Date: May 08, 2007

From: George Penokie (IBM)

Subject: SAS-2:UML changes for logical phys

Figure 1 — Phy class diagram

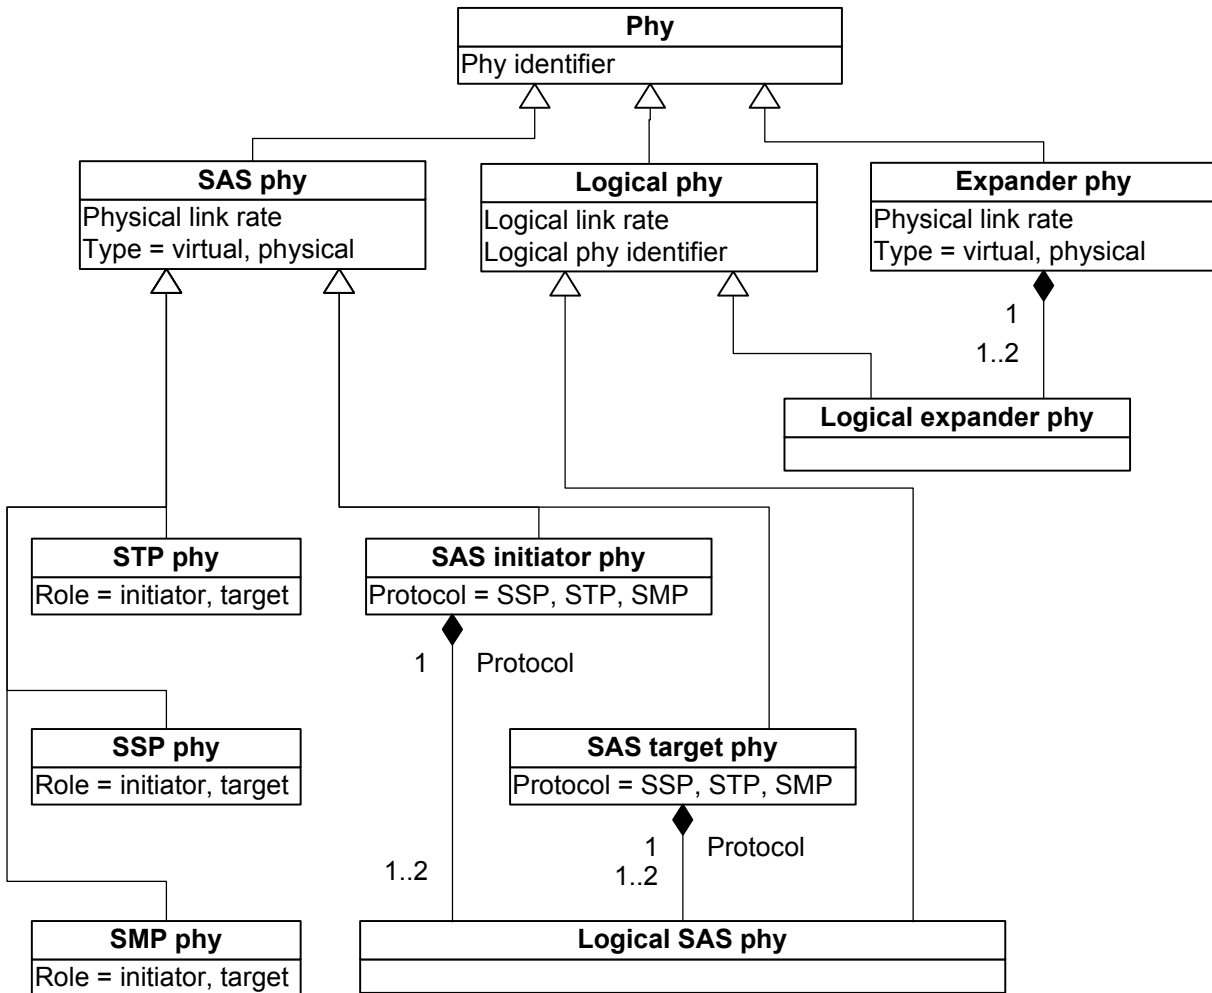
Figure 1 defines the phy classes, showing the relationships between the following classes:

- a) phy;
- b) SAS phy;
- c) logical phy;
- d) expander phy;
- e) logical SAS phy;
- f) logical expander phy;
- g) SAS initiator phy;
- h) SAS target phy;
- i) SSP phy;
- j) STP phy; and
- k) SMP phy.

Figure 2 — SAS phy object and logical SAS phy object diagram

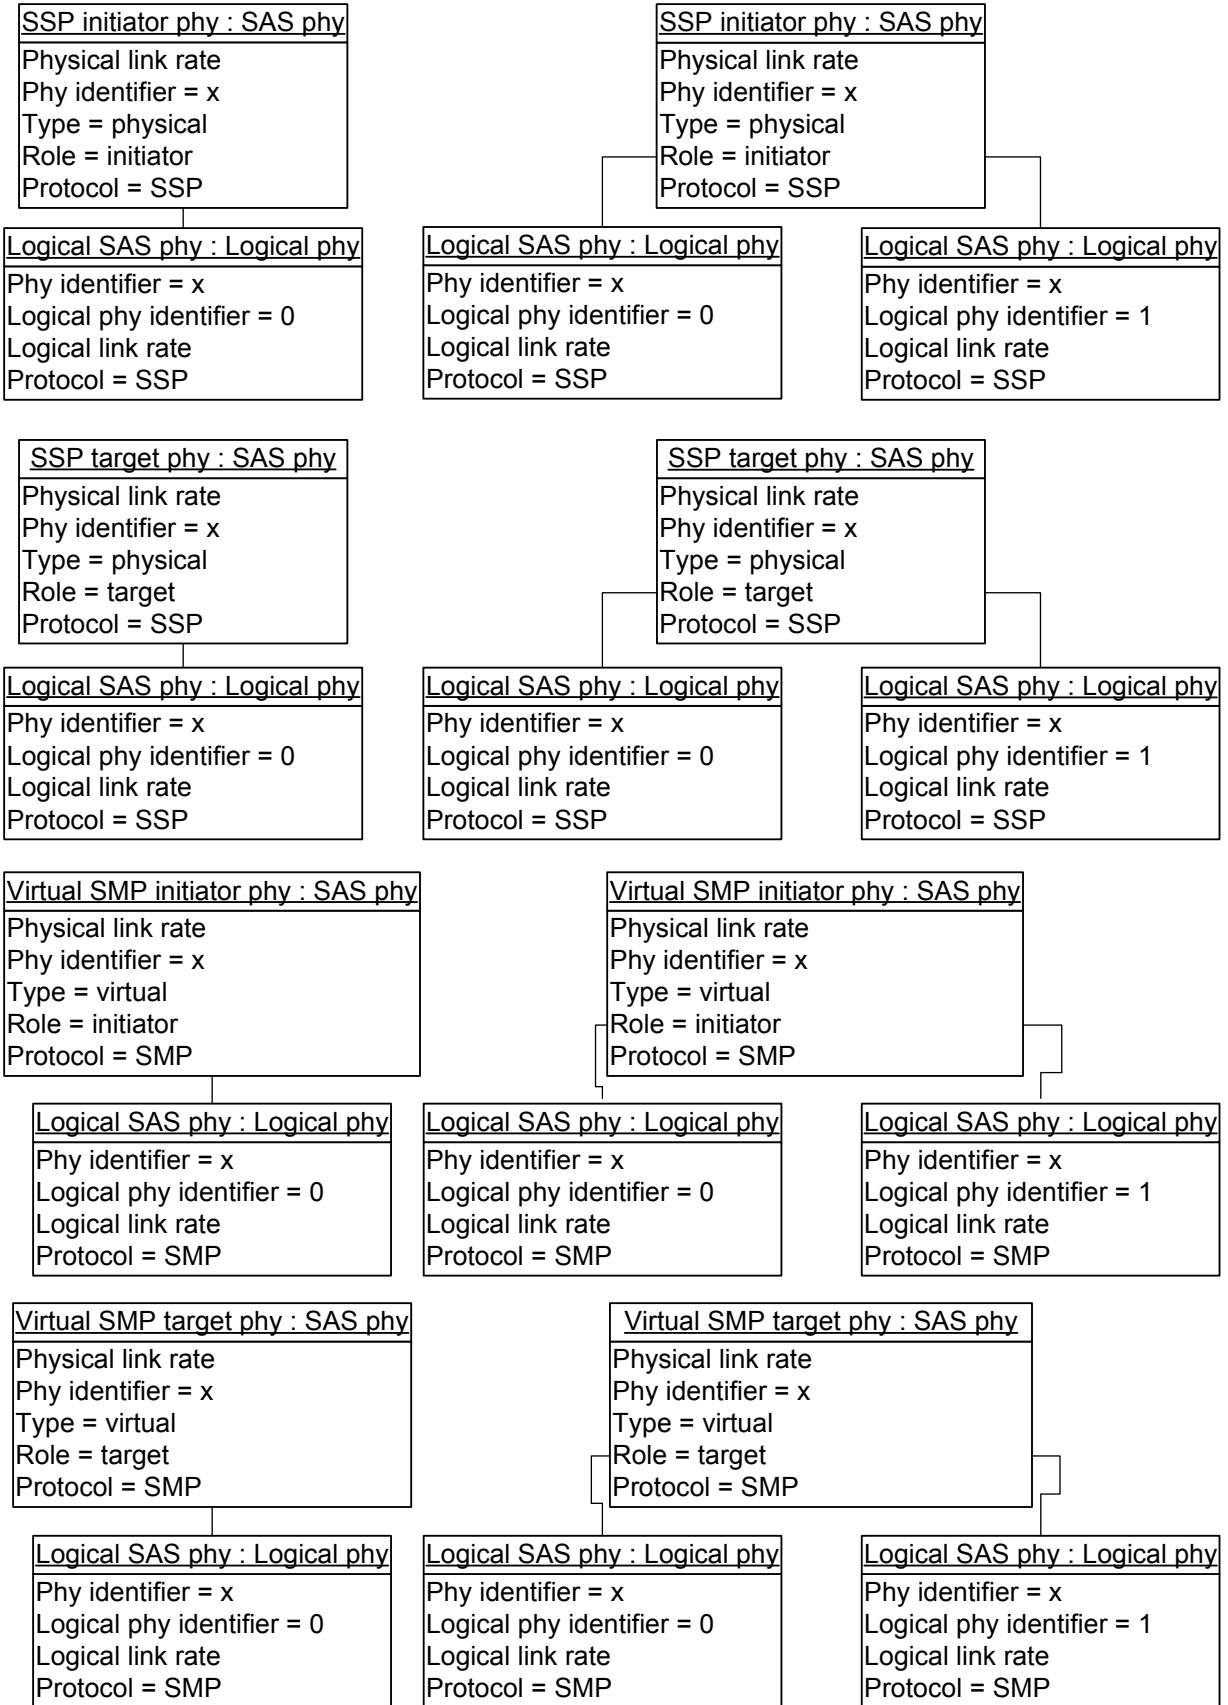
Figure 2 shows the examples objects instantiated from the SAS phy class and the logical phy class, including:

- a) SSP initiator phy;
- b) SSP target phy,
- c) virtual SMP initiator phy;
- d) virtual SMP target phy; and
- e) logical SAS phy.

A SAS phy and logical SAS phy is represented by one of these objects during each connection. A SAS phy and a logical SAS phy may be represented by different SAS phy objects and logical SAS phy objects in different connections.

Figure 3 — Expander phy object diagram

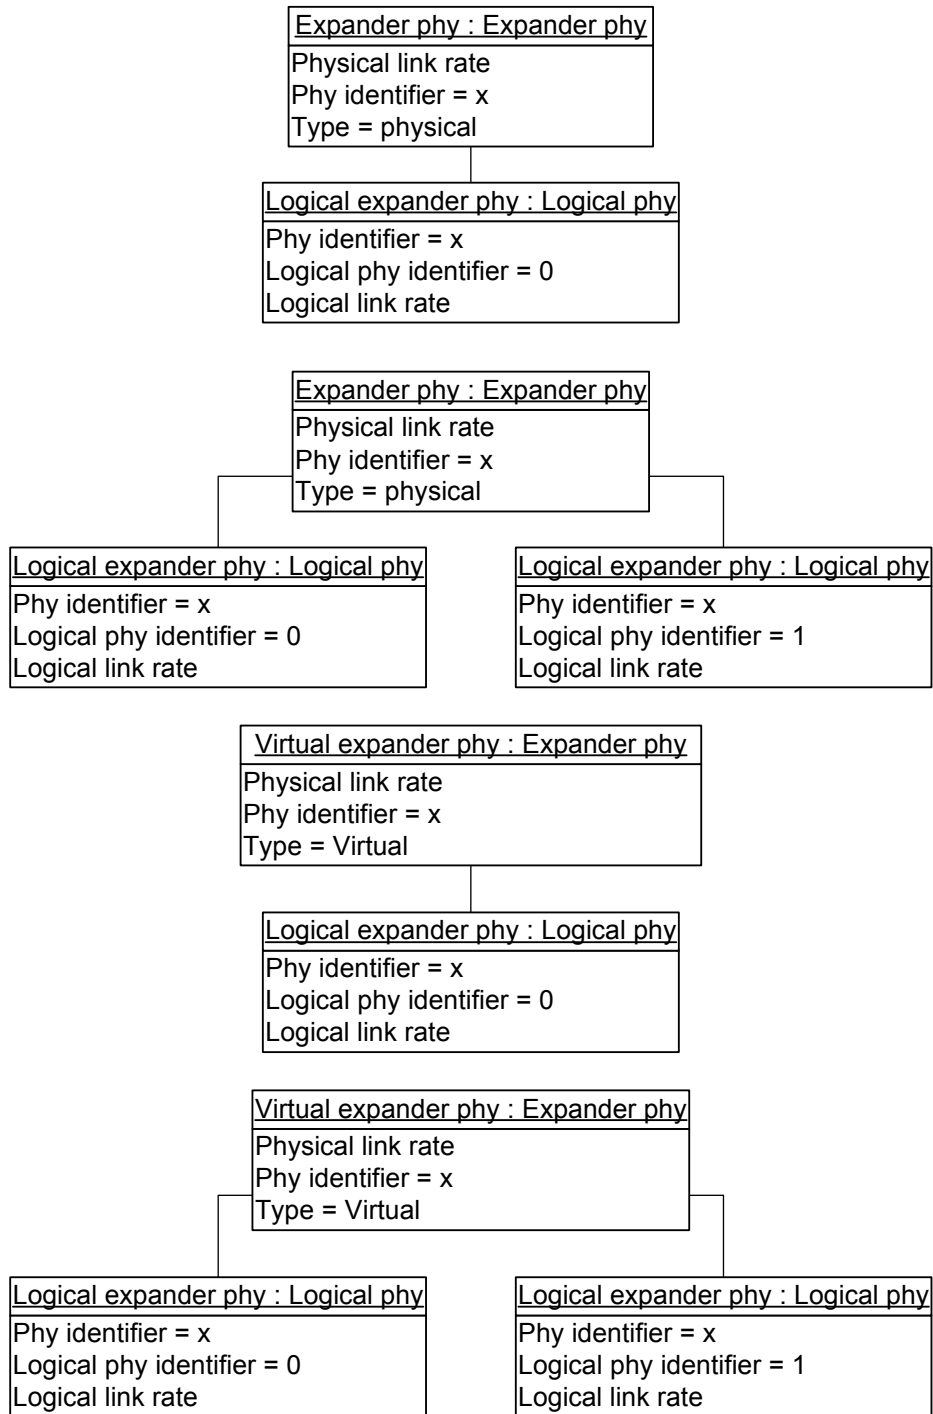
Figure 3 shows the objects instantiated from the expander phy class and the logical phy class, including:

- a) expander phy;
- b) virtual expander phy; and
- c) logical expander phy.

An expander phy and logical expander phy is represented by one of these objects during each connection. An expander phy and a logical expander phy may be represented by different expander phy objects and logical expander objects in different connections.
